PRODUCT CHANGE NOTIFICATION

Bourns® Shielded Power Inductor Core Design Change

Select SRU1038 and PM104SH Models

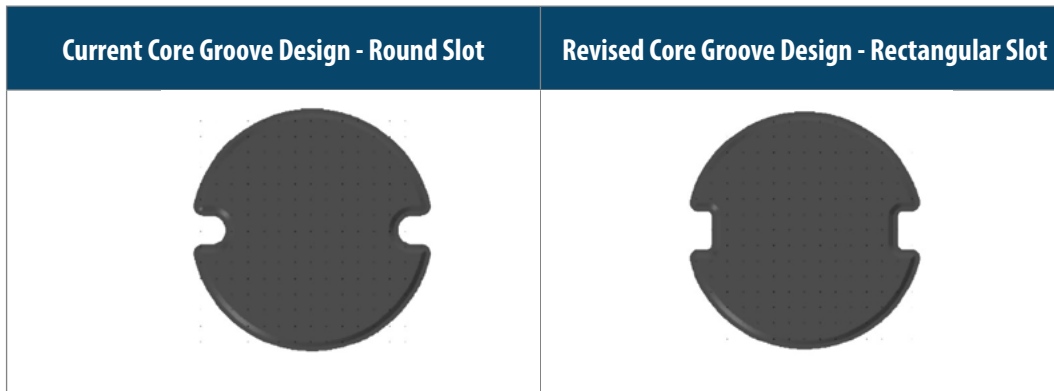
Riverside, California – February 21, 2020 – Bourns is changing the core design of several low inductance power inductor models in the [SRU1038](#) and [PM104SH](#) series. The modification of these select models includes a core groove change from a round slot to a rectangular slot to better accommodate larger diameter wire leads and improve production yield rates. A list of affected part numbers is included below.

The form of the inductor will be changed. The fit and function remain unchanged. The reliability and quality of the inductor should be improved by the core redesign.
